SUBJECT: Exhaust System Tail Pipe Hanger

MODELS AFFECTED: M20C, S/N 1852, 1940-3466, 670001, 670002, 670005-670106
 M20D, S/N 1, 101-260
 M20E, S/N 101-1308, 670001
 M20F, S/N 660001, 660004, 670001-670245, 670247-670257,
 670259-670342

INTRODUCTION: A more durable exhaust tail pipe hanger is available for the aircraft referenced above.

FIGURE No. 2

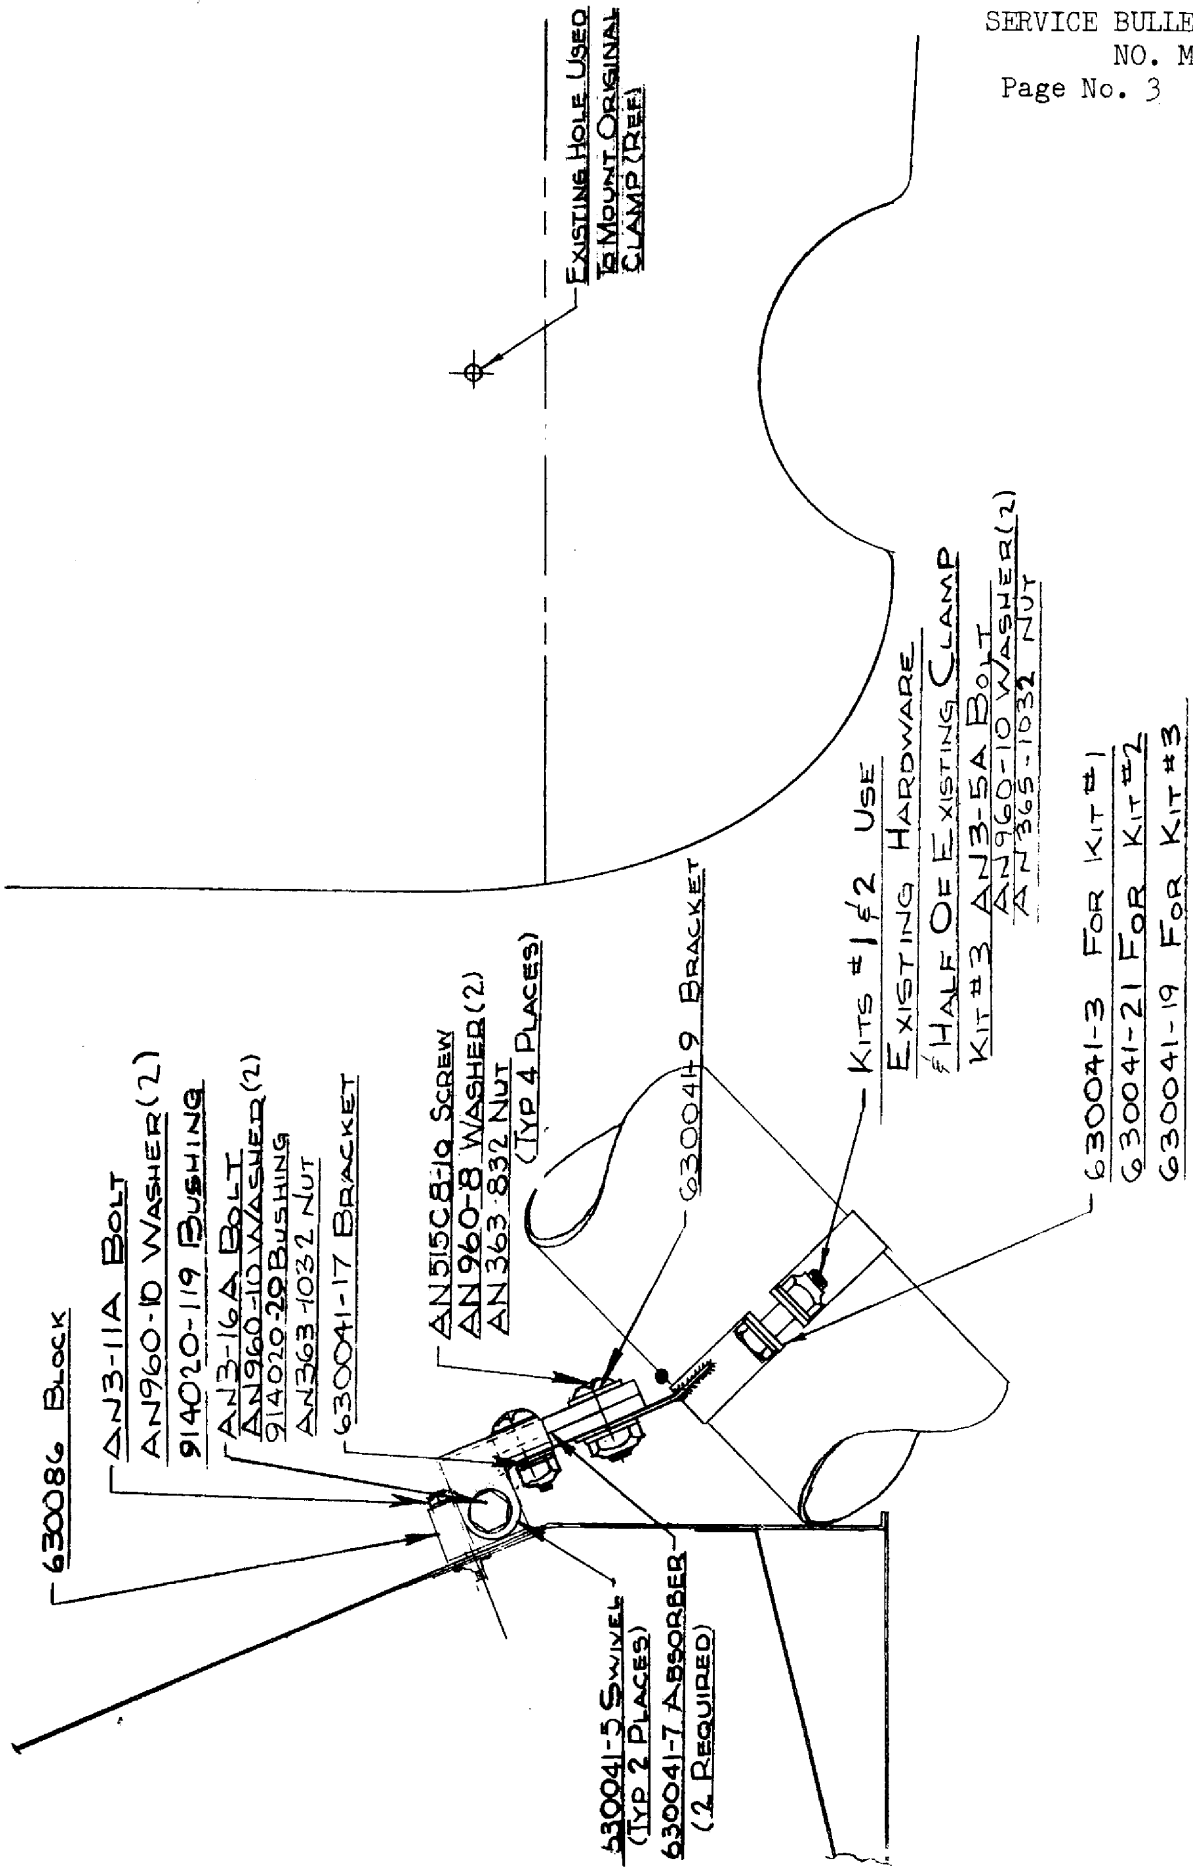
5. Use existing hole in the firewall (see Figure #1).
 6. Install 630086 block on the firewall with one AN3-11A bolt, AN960-10 washer (2), and 914020-119 bushing as shown in Figure #2.

7. Assemble 630041-3 (Kit #2), 630041-19 (Kit #3), or 630041-21 (Kit #1) clamp, two 630041-7 absorbers, 630041-5 swivel, 630041-9 and 630041-7 brackets per Figure #2.
